TRANS/WP.29/GRE/2002/36
17 July 2002

World Forum for Harmonization of Vehicle Regulations (WP.29)

PROPOSAL FOR DRAFT AMENDMENTS TO REGULATION No. 37

(Filament lamps)

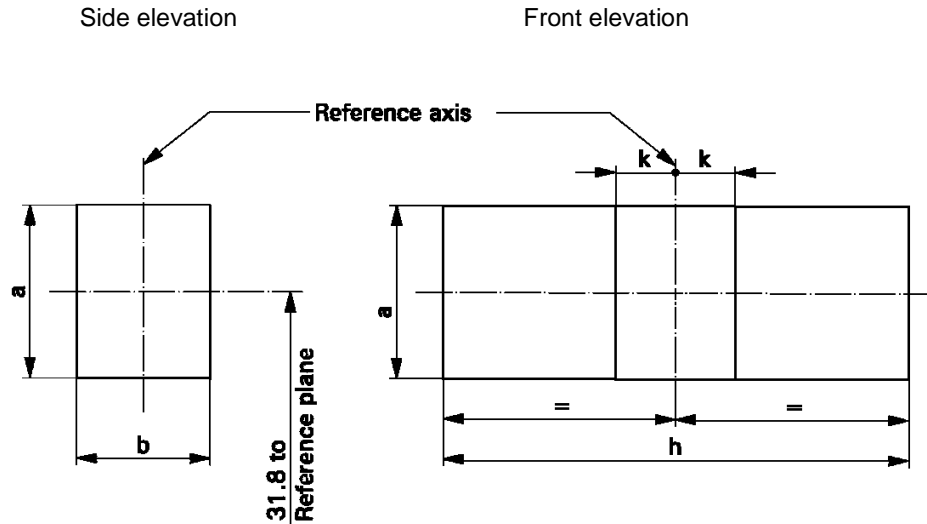
- * Sheet P21W/2 was edited to allow references to this sheet from the amber and red versions datasheets.
- * Sheet R5W was extended with data concerning the red version.
- * Sheets R10W and RY10W were put together and extended with data concerning the red version.
- * Sheet W5W and WY5W were put together and extended with data concerning the red version.
- * Sheet PY27/7W/1 was replaced by a new sheet PY27/7W/1 and sheets ../2 and ../3 were removed. The box system P27/7W is the same for PY27/7W. On sheet ../1 a reference to the box system of the white version was made.

This test is used to determine, by checking whether the filament is correctly positioned relative to the reference axis and reference plane and has an axis perpendicular, within $\pm 15^\circ$, to the plane through the centre line of the pins (P21W) or of the reference pin (PY21W and PR21W) and the reference axis, whether a filament lamp complies with the requirements.

Sheet R5W/1

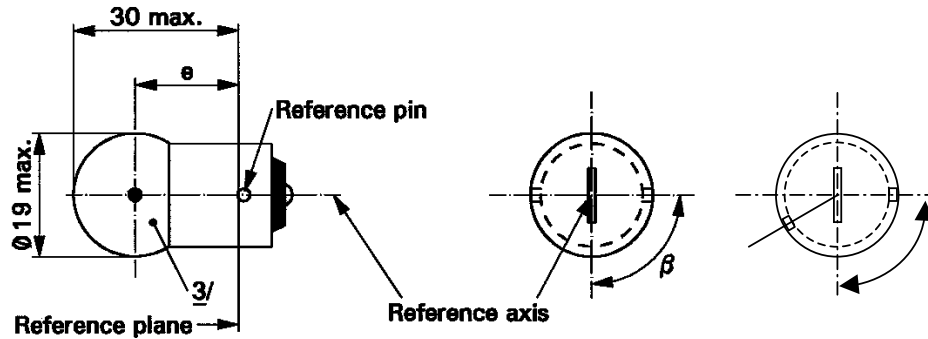
Sheet R5W,

replace by the new sheet R5W and RR5W

Dimensions in mm	Filament lamps of normal production			Standard filament lamp	
	min.	nom.	max.	<u>4/</u>	
e	17.5	19.0	20.5	19.0 ± 0.3	
Lateral deviation <u>2/</u>			1.5	0.3 max.	
β	60°	90°	120°	90° ± 5°	
Cap: R5W: BA15s RR5W: BAW15s	in accordance with IEC Publication 60061			(sheet 7004-11A-9) <u>1/</u> (sheet 7004-...-1)	
ELECTRICAL AND PHOTOMETRIC CHARACTERISTICS					
Rated values	Volts	6 <u>5/</u>	12	24	12
	Watts	5			5
Test voltage	Volts	6.75	13.5	28.0	13.5
Objective values	Watts	5.5 max.		7.7 max.	5.5 max.
	Luminous flux	R5W	50 ± 20 %		
		RR5W	<u>5/</u>	12 ± 25 %	
Reference luminous flux at approximately 13.5 V:	White: 50 lm Red: 12 lm

- 1/ Filament lamps with cap BA15d may be used for special purposes; they have the same dimensions.
- 2/ Maximum lateral deviation of filament centre from two mutually perpendicular planes both containing the reference axis and one containing the axis of the reference pin.
- 3/ The light emitted from filament lamps of normal production shall be white for category R5W and red for category RR5W. (See also note 4/.)
- 4/ The light emitted from standard filament lamps shall be white for category R5W; white or red for category RR5W.
- 5/ Within RR5W no 6 V rated voltage type specified .

Sheet R10W/1

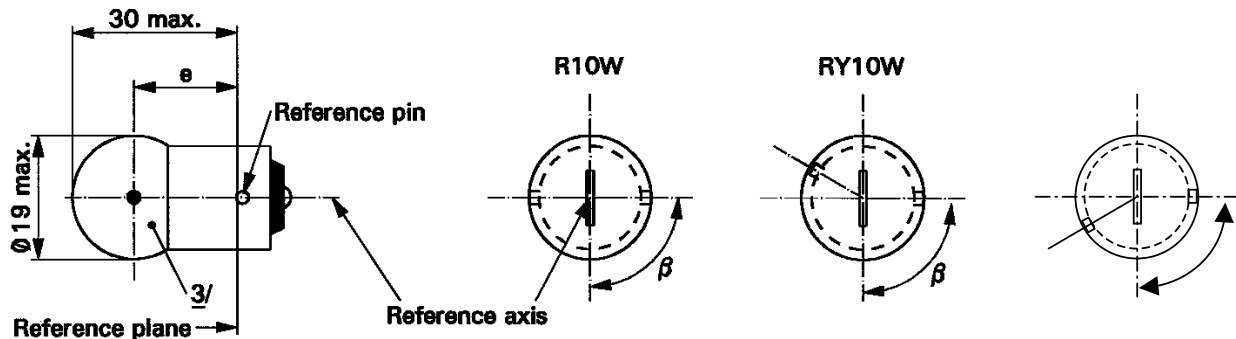
Sheet R10W and RY10W,

replace by the new sheet R10W, RY10W and RR10W

Dimensions in mm		Filament lamps of normal production			Standard filament lamp	
		min.	nom.	max.	<u>4/</u>	
E		17.5	19.0	20.5	19.0 ± 0.3	
Lateral deviation	<u>2/</u>			1.5	0.3 max.	
β		60°	90°	120°	90° ± 5°	
R10W: BA15s Cap: RY10W: BAU 15s in accordance with IEC Publication 60061 RR10W: BAW15s					(sheet 7004-11A-9) <u>1/</u> (sheet 7004-19-1) (sheet 7004-...-1)	
ELECTRICAL AND PHOTOMETRIC CHARACTERISTICS						
Rated values		Volts	6 <u>5/</u>	12	24	12
		Watts	10			10
Test voltage		Volts	6.75	13.5	28	13.5
Objective values	Watts	R10W RY10W	11 max.		14 max.	11 max.
		RR10W	<u>5/</u>	11 max.		11 max.
	Luminous flux	R10W	125 ± 20 %			
		RY10W	75 ± 20 %			
RR10W		<u>5/</u>	30 ± 25 %			
Reference luminous flux at approximately 13.5 V:		White: 125 lm Amber: 75 lm Red: 30 lm

- 1/ Filament lamps R10W with cap BA15d may be used for special purposes; they have the same dimensions.
- 2/ Maximum lateral deviation of filament centre from two mutually perpendicular planes both containing the reference axis and one containing the axis of the reference pin.
- 3/ The light emitted from filament lamps of normal production shall be white for category R10W, amber for category RY10W and red for category RR10W. (See also note 4/.)
- 4/ The light emitted from standard filament lamps shall be white for category R10W; white or amber for category RY10W; white or red for category RR10W.
- 5/ Within RR10W no 6 V rated voltage type specified.

Sheet W5W/1

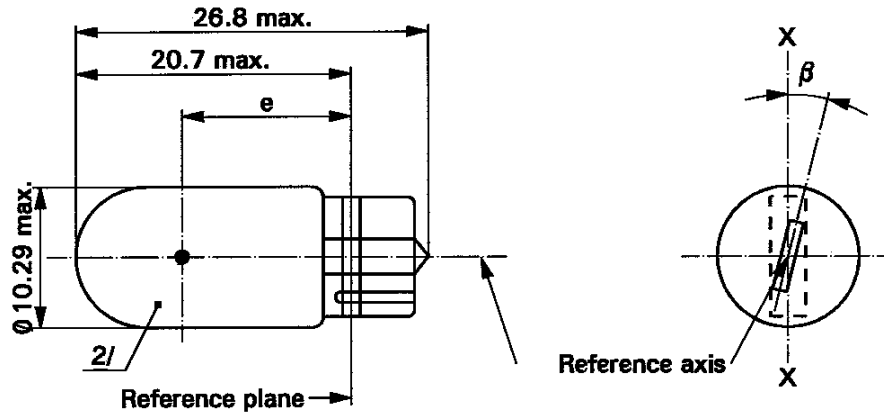
Sheet W5W and sheet WY5W,

replace by the new sheet W5W, WY5W and WR5W

Dimensions in mm		Filament lamps of normal production			Standard filament lamp
		min.	nom.	max.	<u>3/</u>
e		11.2	12.7	14.2	12.7 ± 0.3
Lateral deviation	<u>1/</u>			1.5	0.5 max.
β		- 15°	0°	+ 15°	0° ± 5°
Cap W2.1x9.5d in accordance with IEC Publication 60061 (sheet 7004-91-3)					
ELECTRICAL AND PHOTOMETRIC CHARACTERISTICS					
Rated values	Volts	6 <u>4/</u>	12	24	12
	Watts	5			5
Test voltage	Volts	6.75	13.5	28.0	13.5
Objective values	Watts	5.5 max.		7.7 max.	5.5 max.
	Luminous flux	W5W	50 ± 20 %		
		WY5W	30 ± 20 %		
WR5W	<u>4/</u>	12 ± 25 %			
Reference luminous flux at approximately 13.5 V:		White: 50 lm Amber: 30 lm Red: 12 lm

- 1/ Maximum lateral deviation of filament centre from two mutually perpendicular planes both containing the reference axis and one containing axis X-X.
- 2/ The light emitted from filament lamps of normal production shall be white for category W5W, amber for category WY5W and red for category WR5W. (See also note 3/.)
- 3/ The light emitted from standard filament lamps shall be white for category W5W; white or amber for category WY5W; white or red for category WR5W.
- 4/ Within WR5W no 6 V rated voltage type specified .

Sheet PY27/7W/1

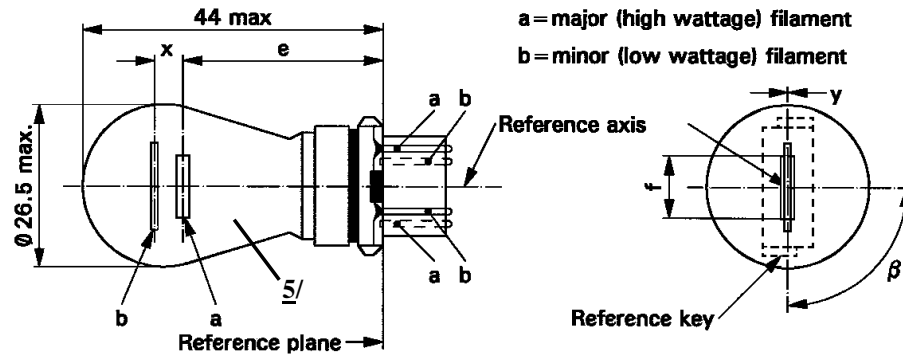
Sheets PY27/7W,
replace by new sheet PY27/7W

Dimensions in mm	Filament lamps of normal production			Standard filament lamp	
	min.	nom.	max.	6/	
e		27.9 3/		27.9 ± 0.3	
f			9.9	9.9 + 0/ - 2	
Lateral deviation 2/			3/	0.0 ± 0.4	
x 4/		5.1 3/		5.1 ± 0.5	
y 4/		0.0 3/		0.0 ± 0.5	
β	75° 3/	90°	105° 3/	90° ± 5°	
Cap WX2.5x16q in accordance with IEC Publication 60061 (sheet 7004-104A-1)					
ELECTRICAL AND PHOTOMETRIC CHARACTERISTICS					
Rated values	Volts	12		12	
	Watts	27	7	27	7
Test voltage	Volts	13.5		13.5	
Objective values	Watts	32.1 max.	8.5 max.	32.1 max.	8.5 max.
	Luminous flux	280 ± 15 %	21 ± 15 %		
Reference luminous flux at approximately 13.5 V:	White: 475 and 36 lm Amber: 280 and 21 lm

- 1/ The reference axis is defined with respect to the reference keys and is perpendicular to the reference plane.
- 2/ Maximum lateral deviation of the major (high wattage) filament centre from two mutually perpendicular planes both containing the reference axis and one containing the axis through the reference keys.
- 3/ To be checked by means of a "box-system", sheets P27/7W/2 and 3.
- 4/ "x" and "y" denote the offset of the axis of the minor (low wattage) filament with respect to the axis of the major (high wattage) filament.
- 5/ The light emitted from filament lamps of normal production shall be amber. (See also note 6/)
- 6/ The light emitted from standard filament lamps shall be amber or white.

Sheet P19W/1

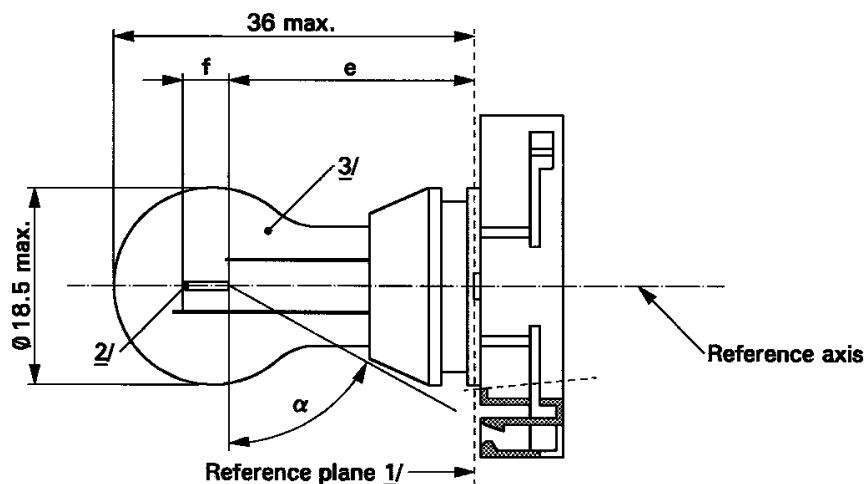
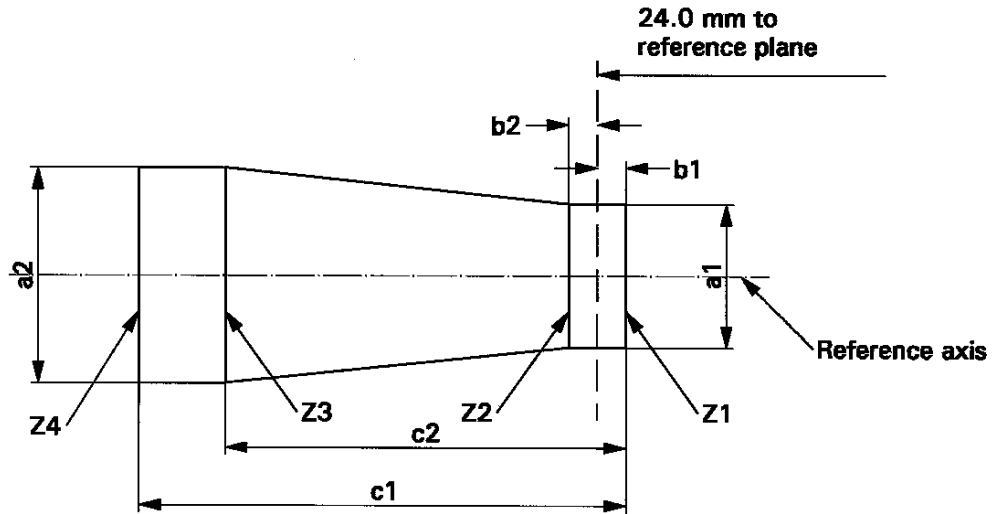
Sheets P19W, PS19W, PY19W and PSY19W,
replace by the new sheets P19W, PY19W, PR19W, PS19W, PSY19W, PSR19W

- 1/ The reference plane is defined by the meeting points of the cap-holder fit.
- 2/ No actual filament diameter restrictions apply but the objective is $d_{max} = 1.1$ mm.
- 3/ The light emitted from normal production lamps shall be white for categories P19W and PS19W; amber for categories PY19W and PSY19W; red for categories PR 19W and PSR 19W. (See also note 8/)

Dimensions in mm	<u>4/</u>	Filament lamps of normal production			Standard filament lamp
		min.	nom.	max.	<u>8/</u>
e	<u>5/</u> <u>6/</u>		24.0		24.0
f	<u>5/</u> <u>6/</u>		4.0		4.0 ± 0.2
α	<u>7/</u>	61.5°			61.5° min.
P19W Cap PGU20-1 PY19W Cap PGU20-2 PR19W Cap PGU20-5 PS19W Cap PG20-1 PSY19W Cap PG20-2 PSR19W Cap PG20-5		in accordance with IEC Publication 60061 (sheet 7004-127-1)			
ELECTRICAL AND PHOTOMETRIC CHARACTERISTICS					
Rated values	Volts	12			12
	Watts	19			19
Test voltage	Volts	13.5			13.5
Objective values	Watts		20 max.		20 max.
	Luminous flux	P19W PS19W	350 ± 15 %		
		PY19W PSY19W	215 ± 20 %		
		PR19W PSR19W	80 ± 20 %		
Reference luminous flux at approximately 13.5 V		White: 350 lm Amber: 215 lm Red: 80 lm

- 4/ For categories PS19W, PSY19W and PSR19W, dimensions shall be checked with O-ring removed.
- 5/ The filament position is checked by means of a "box-system"; sheet P19W/3.
- 6/ The ends of the filament are defined as the points where, when the viewing direction is perpendicular to the plane through the filament lead-in wires as showed in the drawing on sheet P19W/1, the projection of the outside of the end turns crosses the filament axis.
- 7/ No part of the cap beyond to the reference plane shall interfere with angle α. The bulb shall be optically distortion free within the angle 2α + 180°.
- 8/ The light emitted from standard filament lamps shall be white for categories P19W and PS19W; white or amber for categories PY19W and PSY19W; white or red for categories PR19W and PSR19W.

CATEGORIES P24W, PY24W, PR24W, PS24W, PSY24W AND PSR24W**Sheet P24W/1**

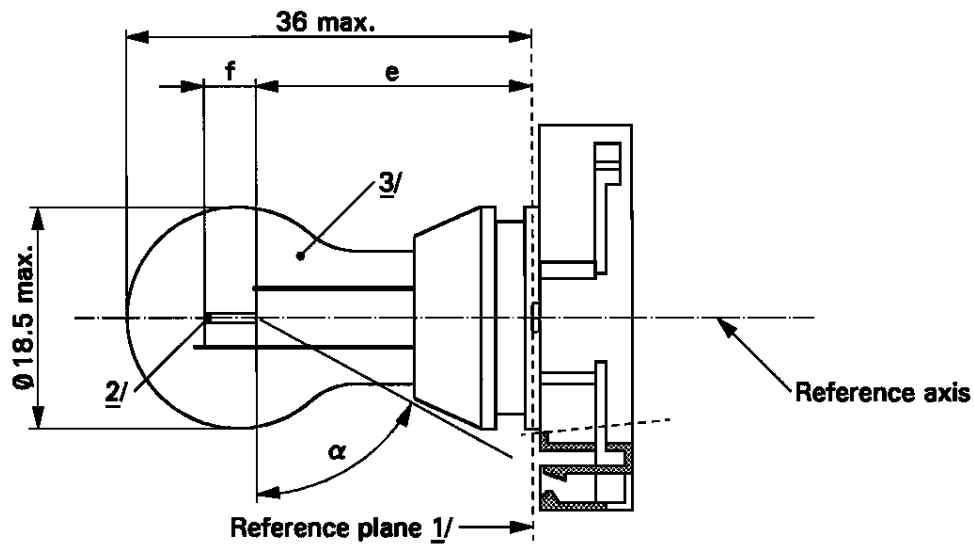
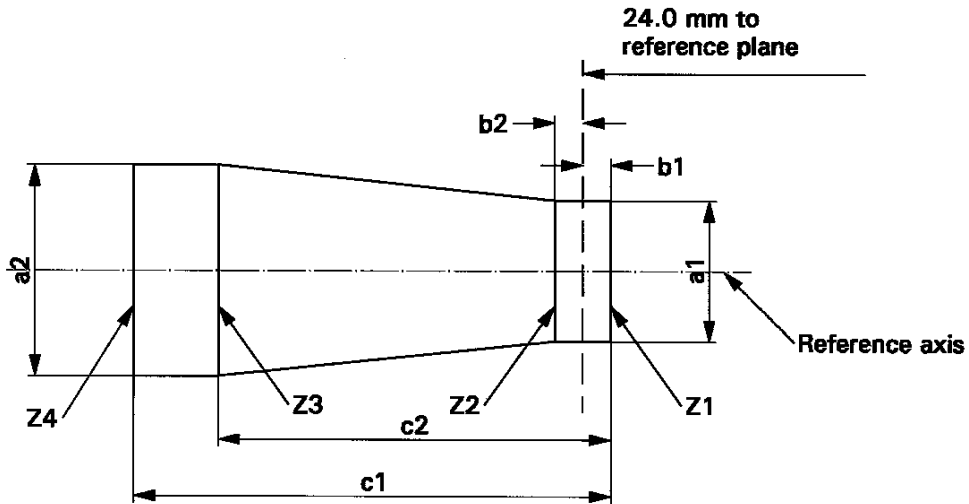
Sheets P24W, PS24W, PY24W and PSY24W,
replace by the new sheets P24W, PY24W, PR24W, PS24W, PSY24W, PSR24W

- 1/ The reference plane is defined by the meeting points of the cap-holder fit.
- 2/ No actual filament diameter restrictions apply but the objective is $d_{max} = 1.1$ mm.
- 3/ The light emitted from normal production lamps shall be white for categories P24W and PS24W; amber for categories PY24W and PSY24W; red for the categories PR24W and PSR24W. (See also note 8/)

Dimensions in mm	<u>4/</u>	Filament lamps of normal production			Standard filament lamp
		min.	nom.	max.	<u>8/</u>
e	<u>5/</u> <u>6/</u>		24.0		24.0
f	<u>5/</u> <u>6/</u>		4.0		4.0 ± 0.2
α	<u>7/</u>	61.5°			61.5° min.
P24W Cap PGU20-3 PY24W Cap PGU20-4 PR24W Cap PGU20-6 PS24W Cap PG20-3 PSY24W Cap PG20-4 PSR24W Cap PG20-6		in accordance with IEC Publication 60061 (sheet 7004-127-1)			
ELECTRICAL AND PHOTOMETRIC CHARACTERISTICS					
Rated values	Volts	12			12
	Watts	24			24
Test voltage	Volts	13.5			13.5
Objective values	Watts		25 max.		25 max.
	Luminous flux	P24W PS24W	500 +10/-20 %		
		PY24W PSY24W	300 +15/-25 %		
		PR24W PSR24W	115 +15/-25 %		
Reference luminous flux at approximately 13.5 V		White: 500 lm Amber: 300 lm Red: 115 lm

- 4/ For categories PS24W, PSY24W and PSR24W, dimensions shall be checked with O-ring removed.
- 5/ The filament position is checked by means of a "box-system"; sheet P24W/3.
- 6/ The ends of the filament are defined as the points where, when the viewing direction is perpendicular to the plane through the filament lead-in wires as showed in the drawing on sheet P24W/1, the projection of the outside of the end turns crosses the filament axis.
- 7/ No part of the cap beyond to the reference plane shall interfere with angle α. The bulb shall be optically distortion free within the angle 2α + 180°.
- 8/ The light emitted from standard filament lamps shall be white for categories P24W and PS24W; white or amber for categories PY24W and PSY24W; white or red for categories PR24W and PSR24W.

Sheet PR21W/1

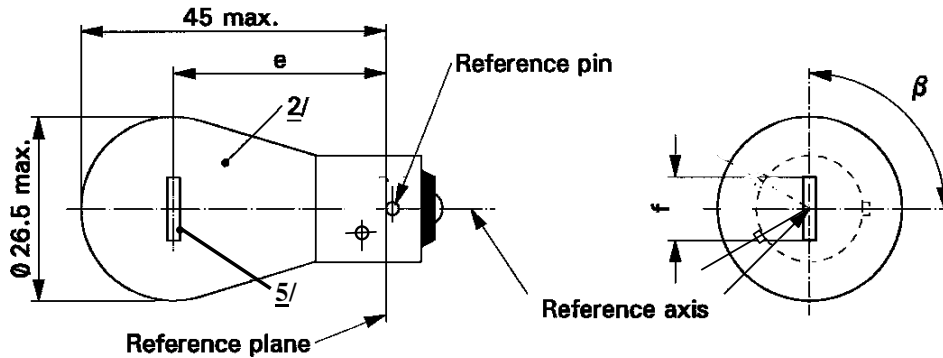
Add at the end new data sheets,
PR21W, PR21/4W, PR21/5W, PR27/7W, to read:

Dimensions in mm		Filament lamps of normal production			Standard filament lamp
		min.	nom.	max.	4/
e	12 V		31.8 3/		31.8 ± 0.3
	24 V	30.8	31.8	32.8	
f	12 V	5.5	6.0	7.0	6.0 ± 0.5
Lateral 1/ deviation	12 V			3/	0.3 max
	24 V			1.5	
β		75°	90°	105°	90° ± 5°
Cap BAW15s in accordance with IEC Publication 60061 (sheet 7004-...-1)					
ELECTRICAL AND PHOTOMETRIC CHARACTERISTICS					
Rated values	Volts	12	24	12	
	Watts	21			21
Test voltage	Volts	13.5	28.0		
Objective values	Watts	26.5 max.	29.7 max.	26.5 max.	
	Luminous flux	110 ± 20 %			
Reference luminous flux at approximately 13.5 V:		White:	460 lm		
		Red:	110 lm

- 1/ Maximum lateral deviation of filament centre from two mutually perpendicular planes both containing the reference axis and one containing the axis of the reference pin.
- 2/ The light emitted from normal production lamps shall be red (See also note 4/).
- 3/ To be checked by means of a "box system", sheet P21W/2.
- 4/ The light emitted from standard filament lamps shall be white or red.
- 5/ In this view the filament of the 24 V type may be straight or V-shaped. This shall be indicated in the application of approval. If it is straight, the screen projection requirements, sheet P21W/2, apply. If it is V-shaped, the filament ends shall be at the same distance within ± 3 mm from the reference plane.
